File In Section: Product Recalls
Bulletin No.: 10282B
Date: March 2011

PRODUCT SAFETY RECALL

SUBJECT: Harsh Transmission Shift, Engine Stall, Engine May Not Start, MIL or Service Engine Soon Lamp

MODELS: 2005-2008 Pontiac Vibe
Two Wheel Drive Equipped with 1.8L MFI Engine (LV6)

2530675

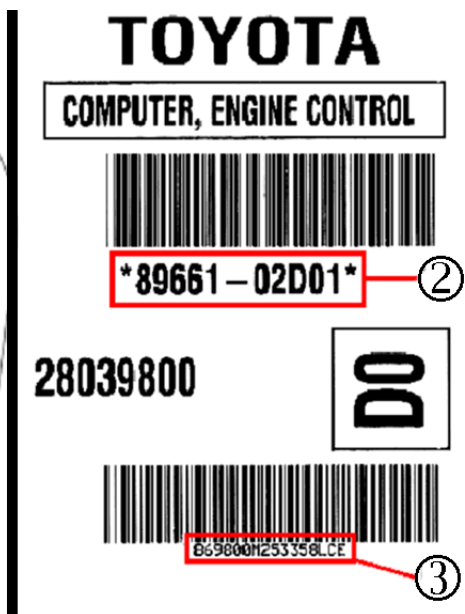
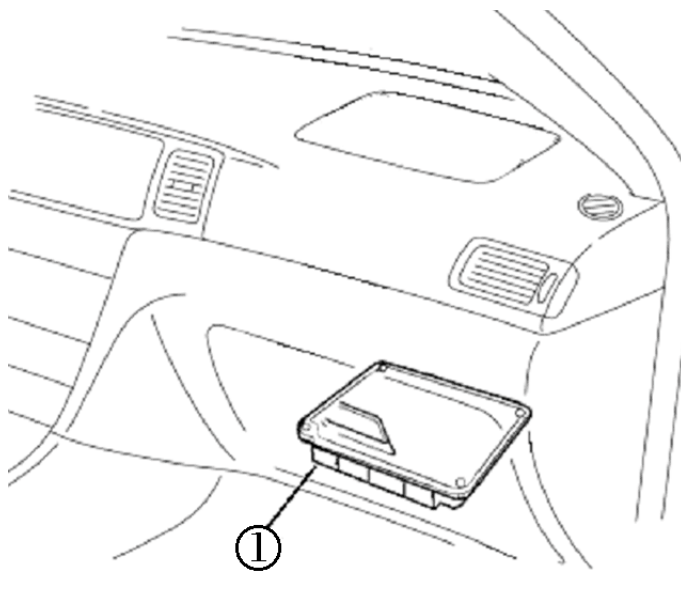
1. Locate the PCM (1) under the glove box compartment.

- Record the part number (2) and the lot number (3) on the repair order.

- Confirm the PCM part number to determine the required action using the table below.

- Confirm the LOT number, if required. Determine the 9th through 12th digits as shown in the following example:

- If the LOT number is 7227 or higher, no further action is required.
- If the LOT number is 7226 or lower, replace the PCM. Refer to *PCM Replacement* in this bulletin.

- Replace the PCM. Refer to *Powertrain Control Module Replacement* in SI.
- Program the vehicle identification number (VIN) to the replacement PCM. Refer to *Control Module References* in SI.
